**U.S. DEPARTMENT OF ENERGY (DOE) REVIEW OF U.S. NUCLEAR REGULATORY COMMISSION'S (NRC) REPOSITORY DESIGN AND THERMAL-MECHANICAL EFFECTS ISSUE RESOLUTION STATUS REPORT, REVISION 2**

Enclosure:  
Comments on Issue Resolution Status Report,  
Revision 2 Key Technical Issue: Repository  
Design and Thermal-Mechanical Effects

**COMMENTS ON ISSUE RESOLUTION STATUS REPORT,  
REVISION 2, KEY TECHNICAL ISSUE: REPOSITORY  
DESIGN AND THERMAL-MECHANICAL EFFECTS**

Figure 1. Shear Strength Curve Based on the Hoek and Brown (1997) Approach (GSI=62,  $\sigma_{ci}$ =167.9 MPa,  $m_i$ =19.68)

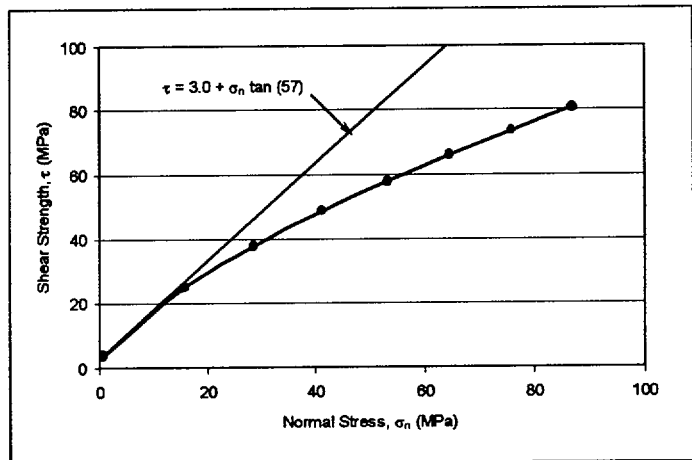
DOE believes that its approach is consistent with the reference cited by the NRC and that the apparent discrepancy is due to the range of the confining pressures used for the curve-fit of the non-linear Hoek and Brown curve to the linear Mohr-Coulomb criterion. The source referenced by the NRC, *Practical Estimates of Rock Mass Strength* (IRSR Reference Hoek and Brown 1997), correctly identifies that “...for values of  $\sigma'_n$  of less than 5 MPa, the straight line, constant  $C'$  and  $\phi'$  method overestimates the available shear strength of the rock mass by increasingly significant amounts as  $\sigma'_n$  approaches zero. Under such circumstances, it would be prudent to use values of  $C'$  and  $\phi'$  based on the tangent to the shear strength curve in the range of  $\sigma'_n$  values applying in practice.” In-situ stresses at Yucca Mountain are relatively low,

in the range 1 to 3 MPa (SNL 1996). Radial stress is zero on the excavation surface and remains small in the vicinity of the excavation profile. The range of confining, or normal stresses, is in the lower non-linear portion of the Mohr-Coulomb failure envelope. DOE utilizes practices recommended by Hoek and Brown 1997, whereby stability analyses typically use a low cohesion and moderately high friction angle.

DOE suggests that utilizing low  $\phi$ , as predicted by the NRC may result in a design that is excessively conservative. DOE believes that using a lower range of normal stress is appropriate (see Figure 1), and friction angles of  $57^\circ$  to  $58^\circ$  are considered more representative of actual conditions observed in the Exploratory Studies Facility and Enhanced Characterization of the Repository Block Cross Drift where the rock mass cohesion of the TSw2 geologic unit is in the range of 1.9 to 3.9 MPa. Figure 1, below, identifies a single tangent point or solution for the low stress range of  $\sigma_1$  - vs -  $\sigma_3$  values (where  $\sigma_1$  and  $\sigma_3$  are maximum and minimum principal stresses) calculated using the Hoek-Brown failure criterion (e.g., IRSR references Hoek, 1994; Hoek and Brown, 1997). Multiple tangents are used to determine the range of  $c$  and  $\phi$  that best describes the linear fit for this section of the curve. Based on tests conducted on core specimens collected from boreholes along the alignment of the ESF North Ramp and Main Drift, the friction angles ranged from  $46^\circ$  to  $58^\circ$  (IRSR reference CRWMS M&O, 1997h, Table 5-32).

Based on the discussion provided above, DOE recommends that the current IRSR narrative discussion (Section 4.3.3.2, Page 31, Paragraphs 2 and 3) be replaced with the following:

The values for the rock-mass strength parameters  $c$  and  $\phi$  currently proposed for YM (CRWMS M&O, 1997a) were estimated by fitting straight lines to sets of  $\sigma_1$  - vs -  $\sigma_3$  values (where  $\sigma_1$  and  $\sigma_3$  are maximum and minimum principal stresses) calculated using the Hoek-Brown failure criterion (e.g., Hoek, 1994; Hoek and Brown, 1997).

The procedure presented by Hoek and Brown (1997) for estimating  $c$  and  $\phi$  is based on the GSI index. The values of this index can be determined through geologic mapping of the rock mass following guidelines described by Hoek and Brown (1997) or estimated through correlations with  $Q$  or RMR. The values of  $c$  and  $\phi$  obtained using this procedure (Ofoegbu, 1999) with the TSw2 section of the ESF  $Q$  data (Figure 2) are given as functions of  $Q$  in Figure 4. The figure shows  $\phi$  varying from about  $28^\circ$  to about  $35^\circ$  as  $Q$  varies from about 0.73 to about 13.6. These values of  $\phi$  are much smaller than the DOE values presented previously. The difference between the CRWMS M&O (1997a)  $\phi$  values of  $57^\circ$ - $58^\circ$  and the values in Figure 4 ( $28^\circ$ - $35^\circ$ ) for the same range of  $Q$  values is quite significant in

predicting the mechanical behavior of the rock mass in the vicinity of the proposed waste-emplacement openings (e.g., see the numerical-model results discussed presently).

The practice of using values of  $c$  and  $\phi$  based on the tangent to the shear strength curve in the range of normal stress values is recommended by Hoek and Brown (1997) because of the low normal, or radial stress around the opening. The range of radial stresses around the opening is in the lower non-linear portion of the Mohr-Coulomb failure envelope, where the method of using a constant  $c$  and  $\phi$  from the broader range of normal stresses overestimates the available shear strength of the rock mass at the vicinity of the tunnel opening. Friction angles of 57 to 58° are considered to be more representative of actual conditions observed in the Exploratory Studies Facility and Enhanced Characterization of the Repository Block Cross Drift, where the rock mass cohesion of the TSw2 geologic unit is calculated in the range of 1.9 to 3.9 MPa.
